ROUX MEMORANDUM

DATE: March 13, 2017

RE: Meeting with NYSDEC Region 3
Hastings-on-Hudson Conceptual Shoreline Plans

Conceptual Design Elements Hastings-on-Hudson Shoreline

Site North

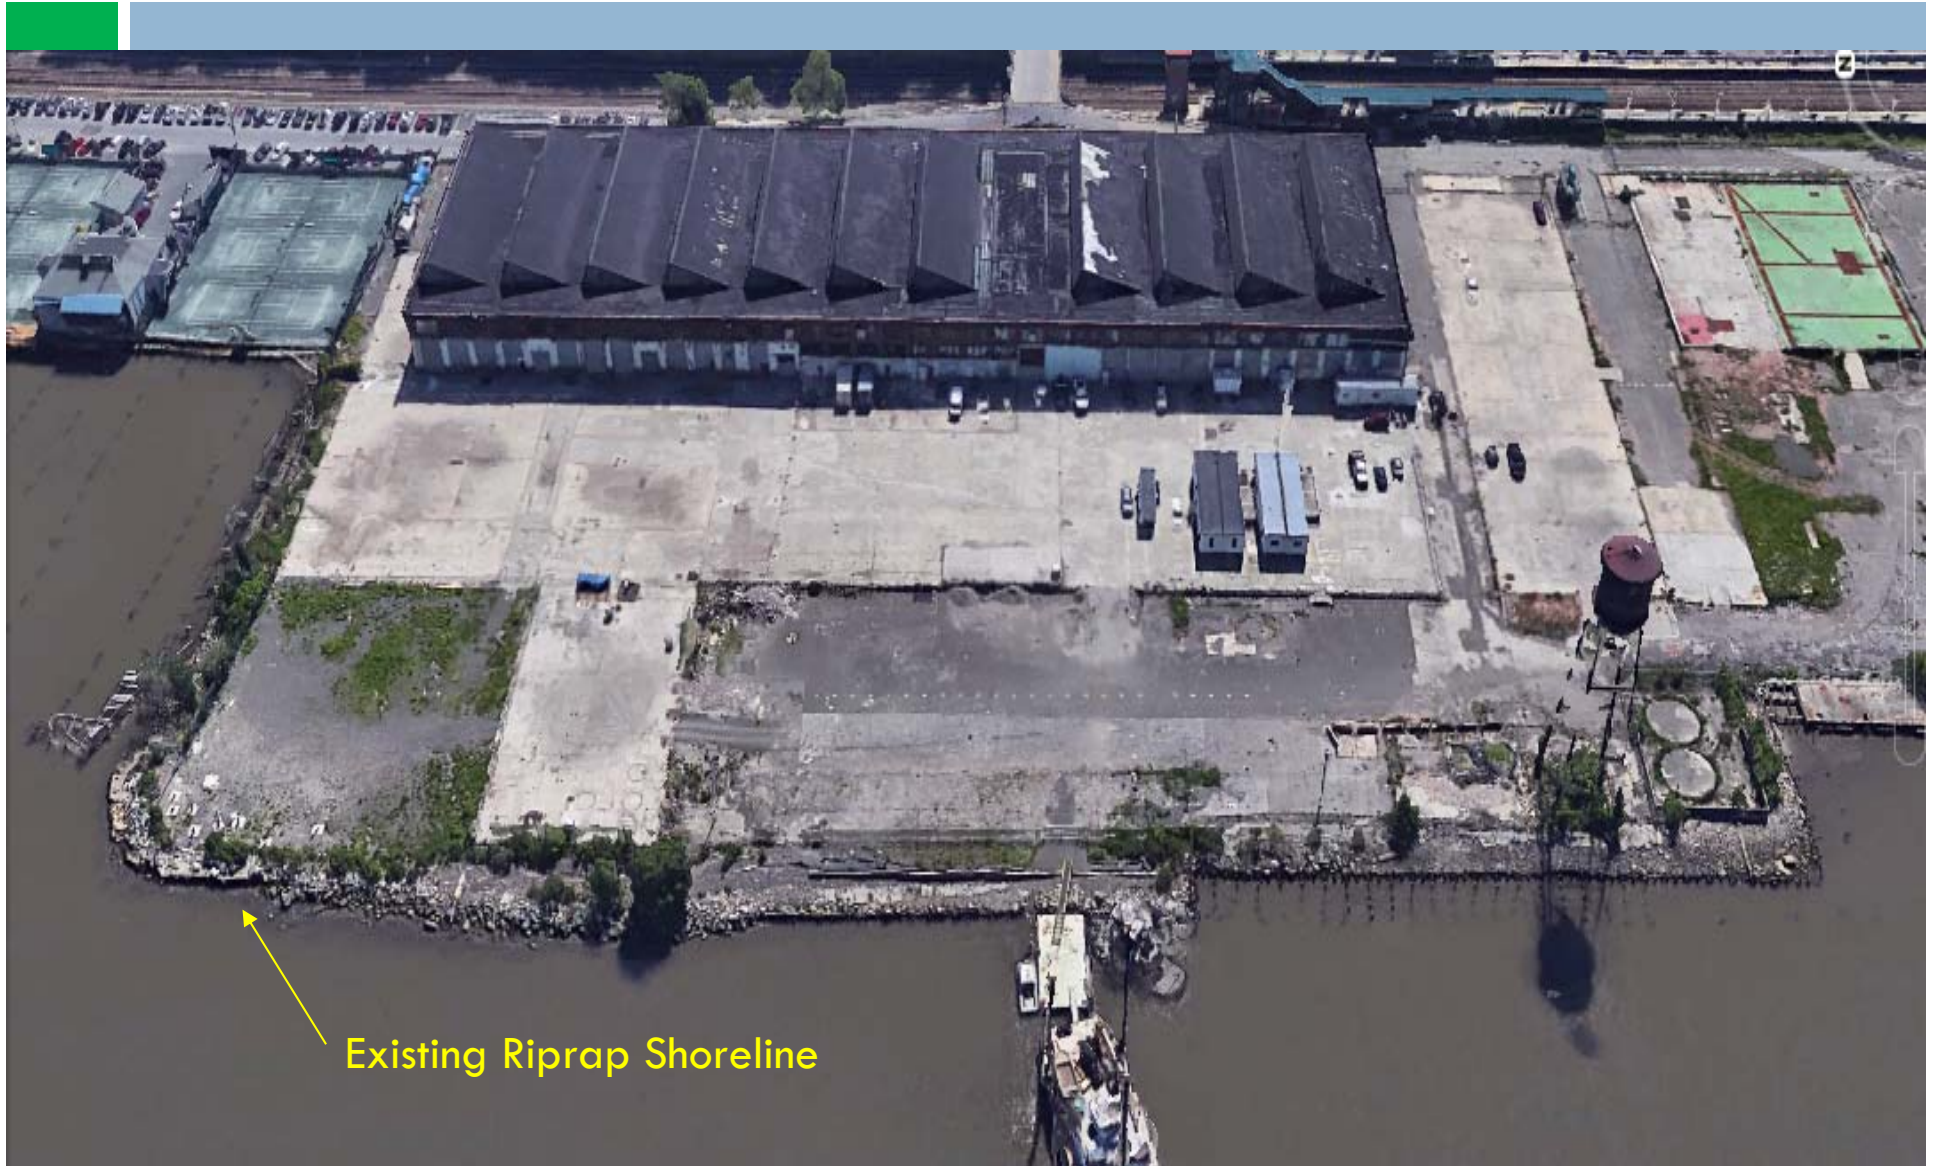
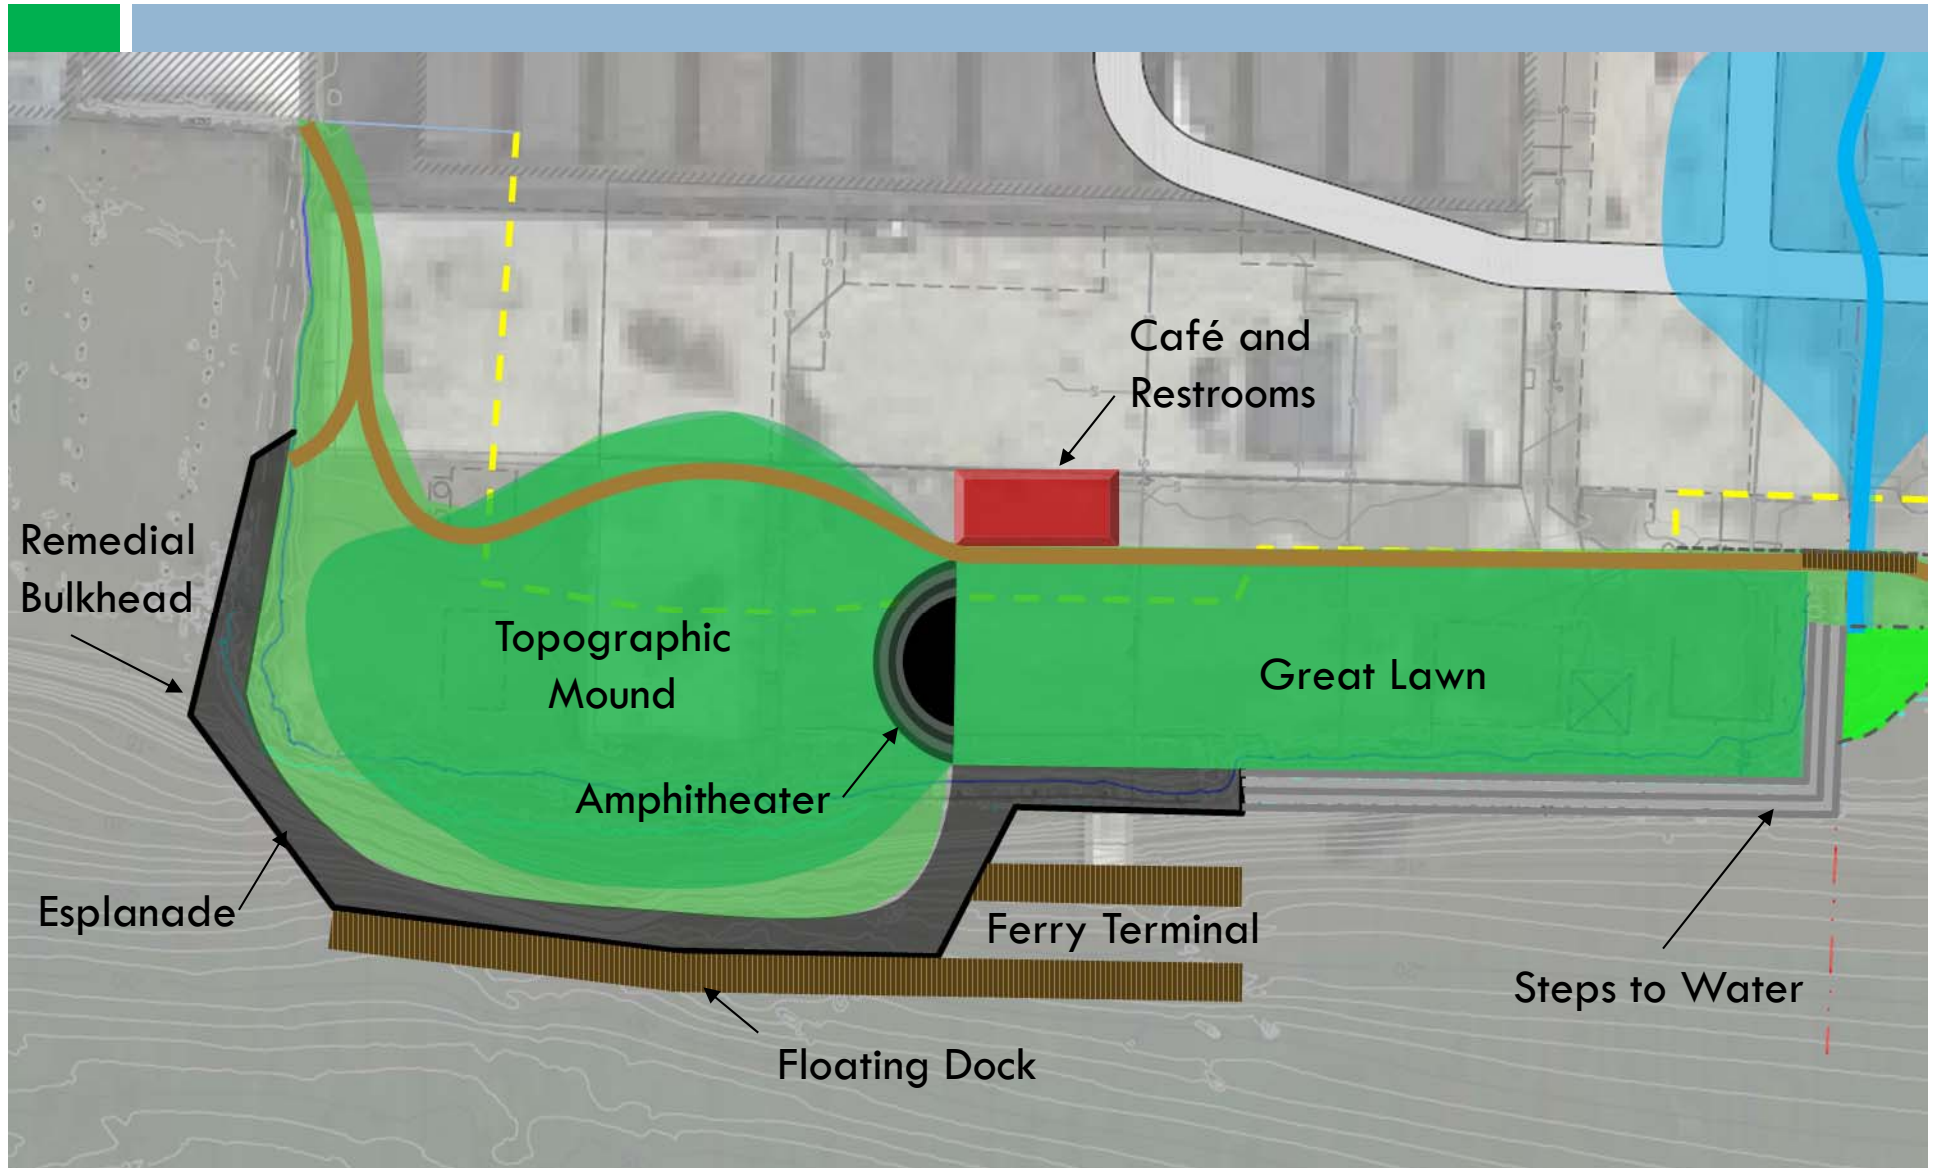
Heather Gierloff – The ferry terminal and floating docks would not be considered under the remediation design; these structures would require separate Tidal Wetland Permits from the NYSDEC (based on Article 25, Section 661 requirements within adjacent areas 300’ from tidal wetland). The docking facility cannot exceed 40,000 square feet or a Docks and Mooring permit will be required. The permit application would need to demonstrate the need for these structures based upon examples of other ferry’s and public opinion. These permits could be obtained later by the Village of Hastings and/or a developer. The floating dock running parallel to the bulkhead would not be a feasible design element for that area for small boats due to the wake created by boats along the Hudson River, but could be built in a protected area, such as south of the Northwest Corner fill area.

The footprint of the waterfront access steps as shown would likely not be permitted; the footprint would need to be reduced to match only the bulkhead area that will be potentially included in the Remedial Design and the steps would also need to be set back so that filling within the Hudson River would not be required.

Jacquelyn Nealon – There will be recovery wells and a pump house potentially located around the perimeter of the Northwest Corner, where the hill and esplanade are shown. The Remedial Design will confirm the location of these remedial elements; however these areas may be restricted from public access and vehicle access into these areas may be required.

North Cove

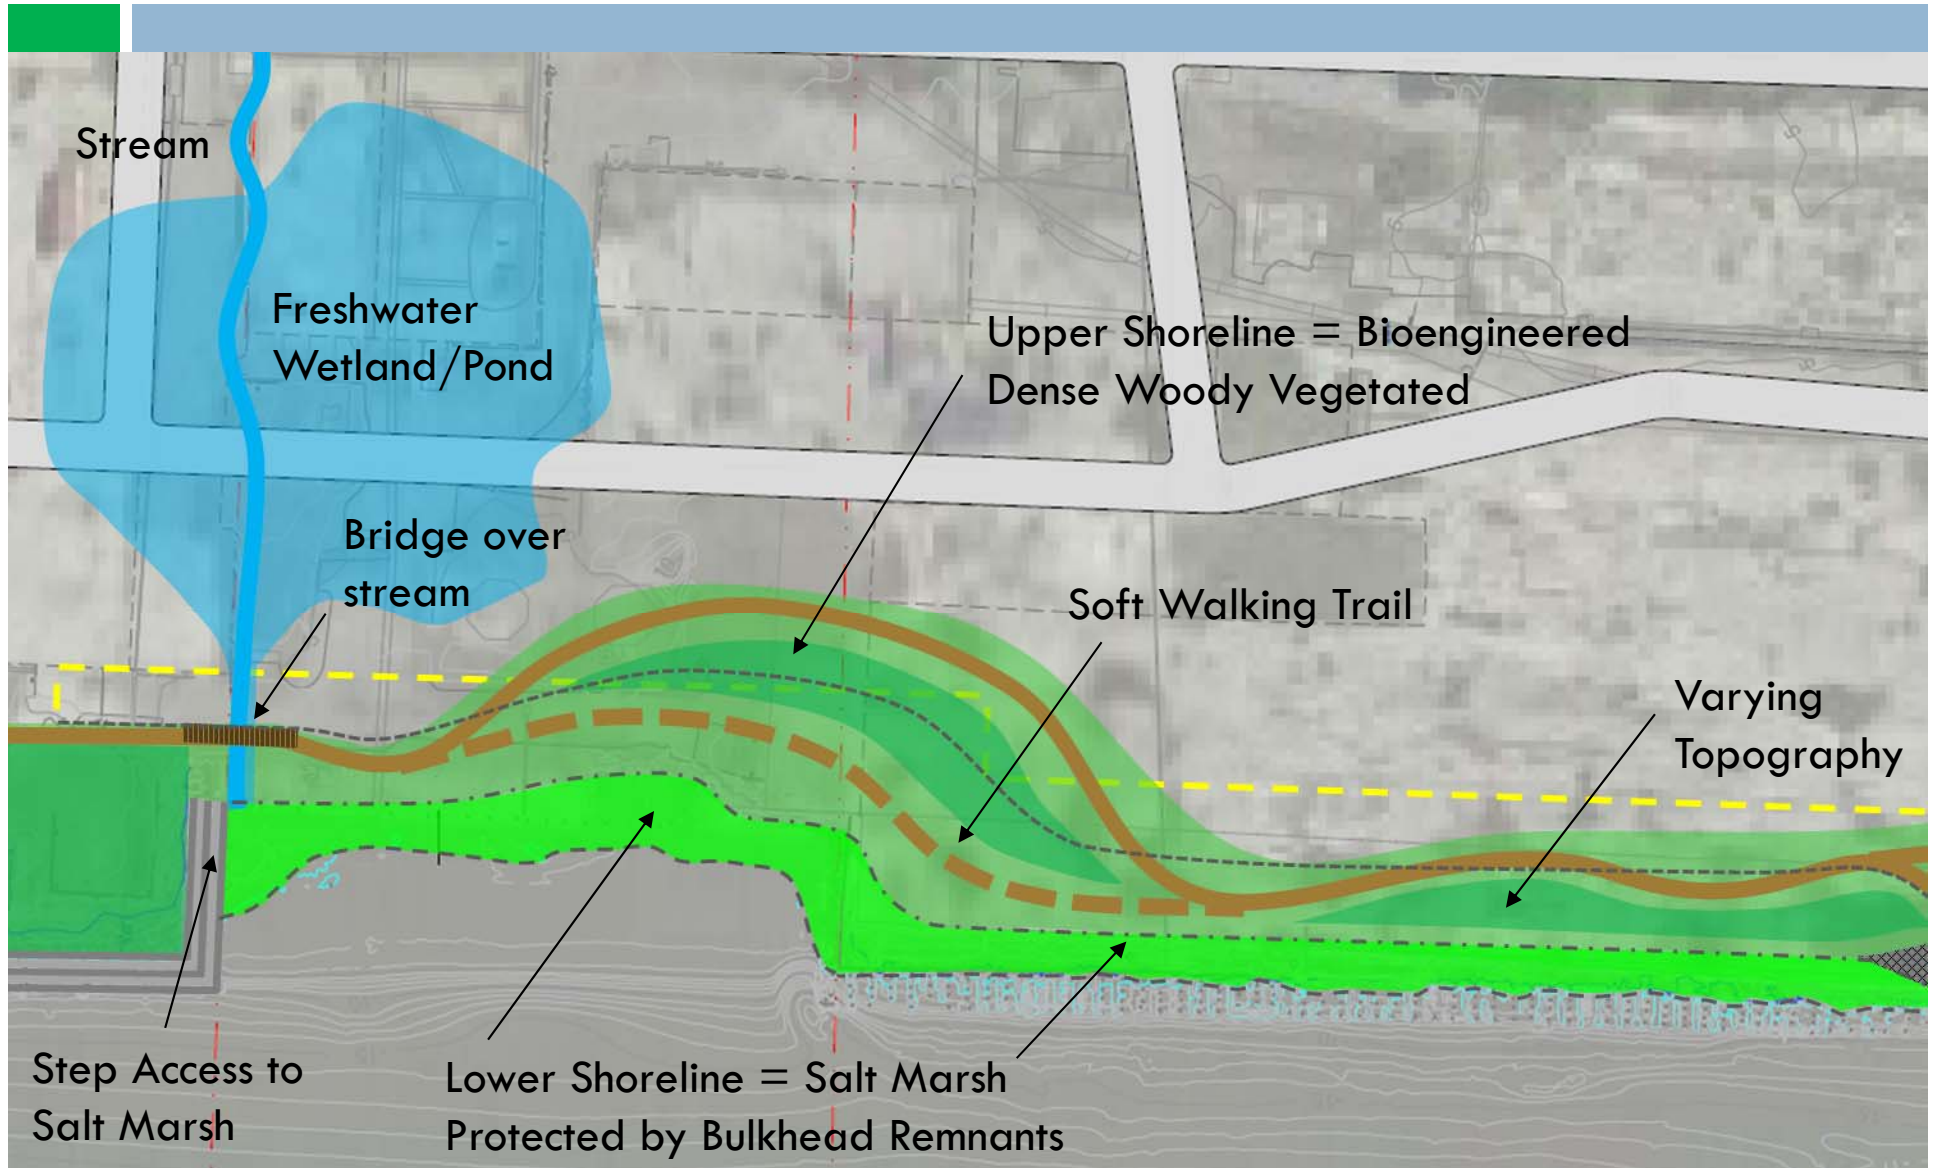
Corbin Gosier – Mitigation requirements for the filling that will be needed in the Northwest corner of the property are not yet known and will be determined upon NYSDEC review of the Remedial Design. The ratio could be as high as 4:1 or 5:1. Mitigation requirement will likely be intertidal marsh (from -2' to +2') as this type of habitat is lacking along the Hudson River. The BP Operation, Maintenance and Monitoring (OMM) requirements for the shoreline restoration and the remedial elements will also be evaluated as part of the alternatives analysis within the Remedial Design and the final OMM requirements will be included in the Site Management Plan upon implementation of the selected remedy. Dredging will be required along 2,000 linear feet of shoreline at a distance of 60 to 80 feet from the shoreline to a depth of approximately 6 feet in areas where depths are 15 feet. Excavation depths will be dependent upon water depth and concentrations of PCBs present (refer to ROD for Operable Unit Number 02 (OU-2)). The dredging and backfilling within the river will require a 401 Water Quality Certificate which means there will have to be some level of detail for shoreline creation by BP. The piers that are currently present (supporting sheet pile bulkhead) will likely all be removed during remediation (refer to ROD for OU-2). Some of the excavated material may be able to be reused for filling in uplands to create the proposed varying topography. Where backfill is required, wave breaks could be designed into new sediment fill. (See example of this between Stillwater and Schuylerville on upper Hudson River.)

Heather Gierloff – Step access to salt marsh will be generally incompatible with tidal wetland regulations unless installation of bulkhead is necessary as part of the remedial design. The area where the steps are shown is also an area where the NYSDEC was initially thinking could be used to create habitat to fulfill the mitigation requirements associated with the filling in the northwest corner of the Site. In general, due to the strong wave action caused by boat wakes along the

Hudson River, salt marsh restoration that incorporates rip rap up to MHW is the most successful. Tidal wetland plantings in Haverstraw have to be repaired because they were not protected enough and do not have sufficiently shallow slopes. Any sills proposed to protect wetland plantings would need to be installed above the average mean high water line. However since this is a productive fish area the NYSDEC may not support filling the area with rock. Ice flows are generally not an issue along this stretch of the Hudson River. A deeper cap would be required to accommodate the proposed woody plantings, depending upon the Remedial Design, to ensure the plantings would not penetrate the remedial cap. Planting of woody species could be coordinated with remediation: areas with more excavation would provide room for roots.

South Cove

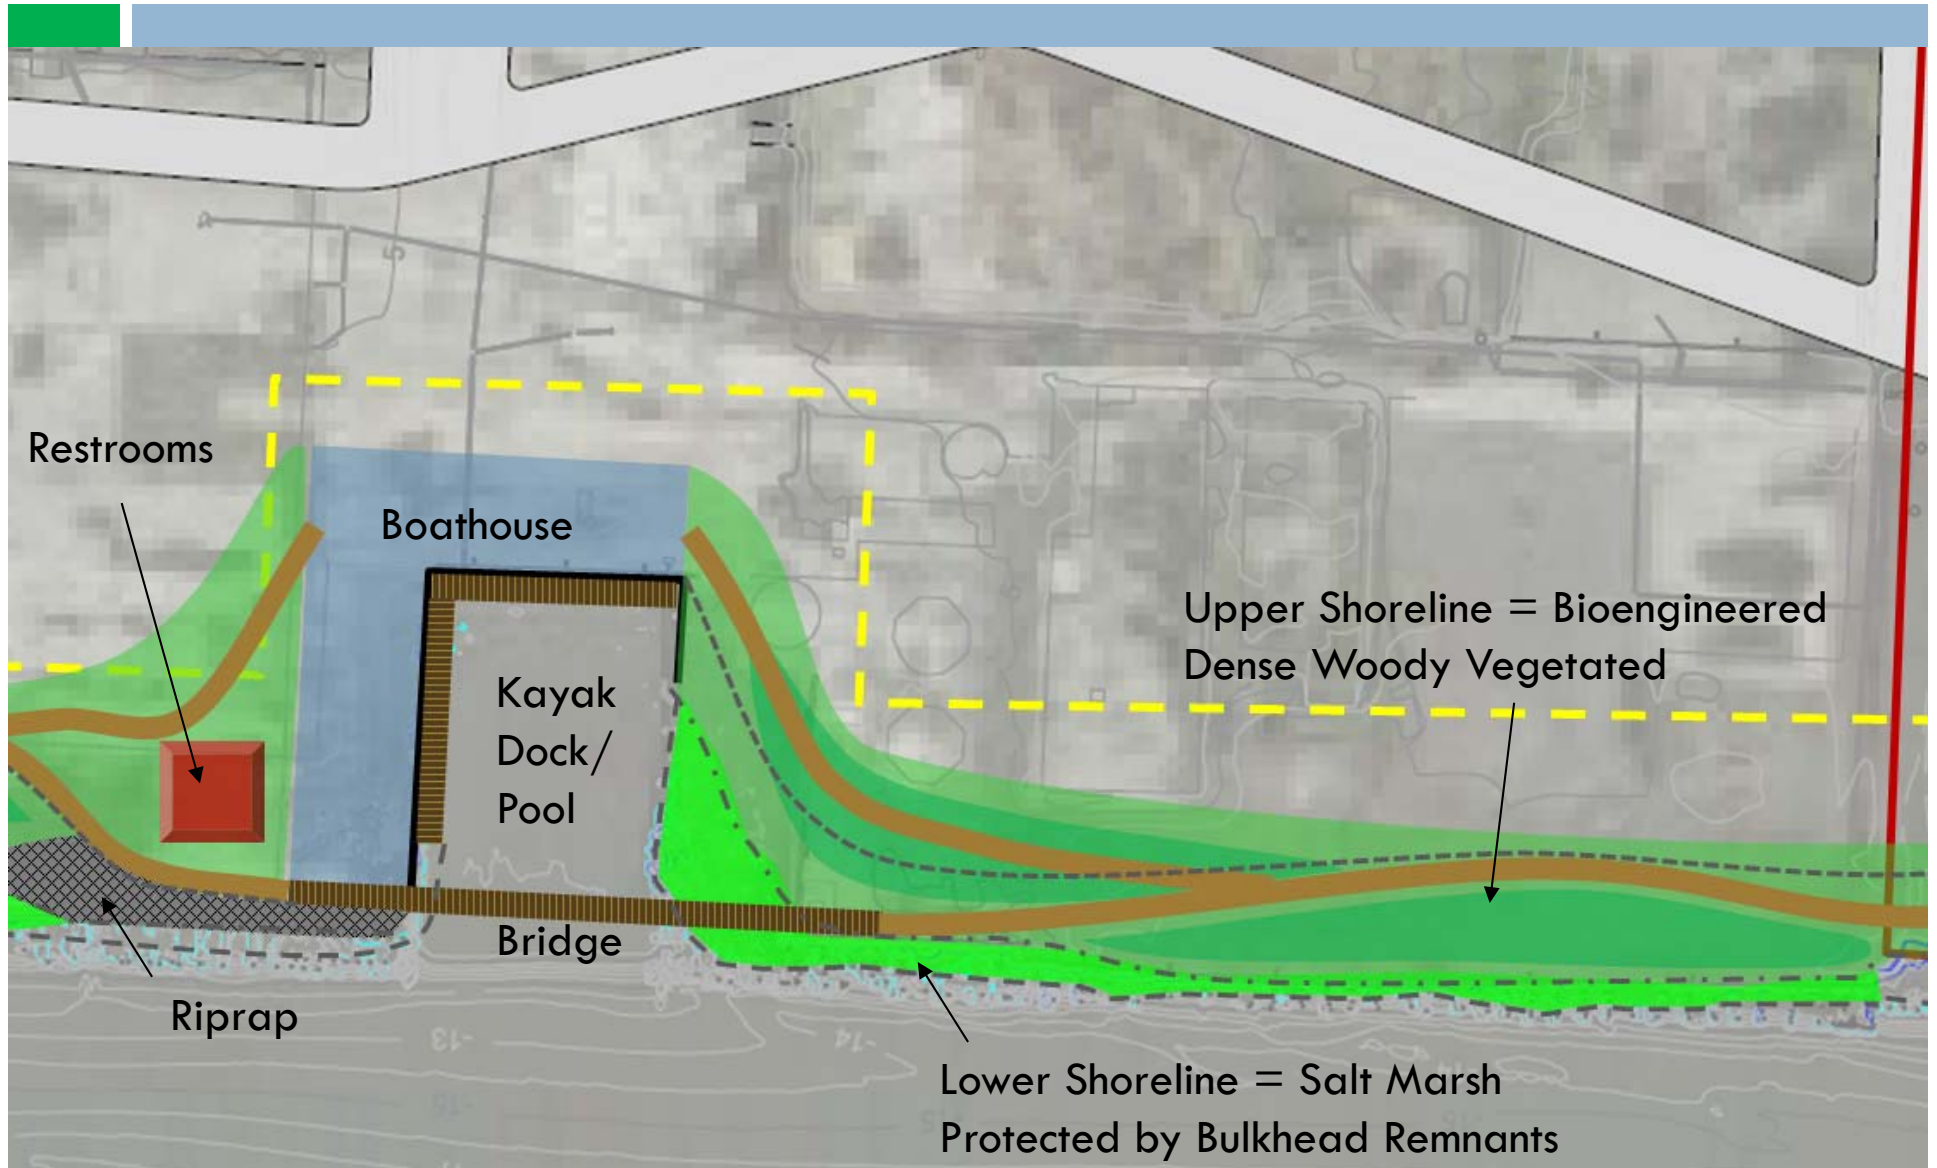
Refer to comments from North Cove Design Elements related to the salt marsh creation behind the bulkhead remnants and piers, and woody plantings.

Heather Gierloff – The proposed boathouse would require a Tidal Wetlands Permit, however, due to the anticipated wetland mitigation requirements that will likely rely on the south cove as an area for habitat creation and based upon the size and location of the proposed boathouse the reality is modifications to the proposed boathouse elements would be necessary in order to receive a permit. The wetland mitigation requirements will be determined upon NYSDEC review of the Remedial Design. The NYSDEC wants intertidal wetland habitat to replace the river bottom areas that will be filled as part of the Remedial Design and upland habitat creation will not be an acceptable wetland mitigation offset to compensate for the loss of river bottom habitat. A kayak launch would be ok but it would need to be smaller and be respectful to the mitigation that will likely be located in this area. All permanent structures will need to be set back 50 feet from the shoreline, including any proposed boat storage areas and restrooms. A separate permit for boat storage would be needed, but kayak launch could be part of remediation permit; it would not be included as part of the remediation. A floating dock would need to be less than 200 square feet to meet Tidal Wetland compatibility requirements and it would need to be located off the mudline during low tide.

Stormwater and Flood Control

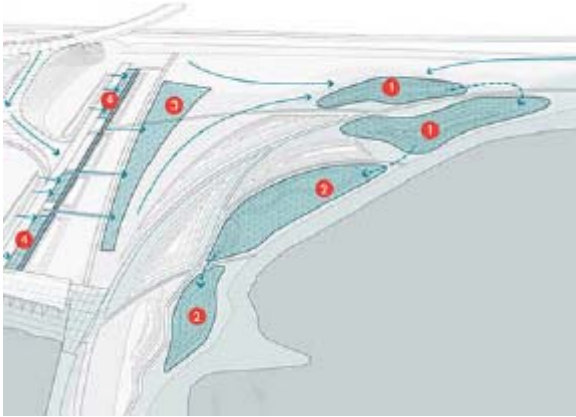
Refer to comments from Heather regarding setting back all permanent structures 50 feet from the shoreline. Shorelines that incorporate both riprap and plantings are the most successful along the Hudson River.

Jacquelyn Nealon – There have been trespassing issues with the entire site for years now. By creating public access you are also creating an attractive nuisance. Fish consumption is not allowed along the Hudson River. She would suggest posting a public advisory along the walkways and piers to discourage fish consumption and also to discourage the public from walking barefoot. There are public health concerns associated with direct contact with sediments impacted from sanitary sewer overflows, and in the lawn or park areas from goose droppings. The NYSDOH would not encourage the public to walk barefoot in these areas due to high bacterial concerns.
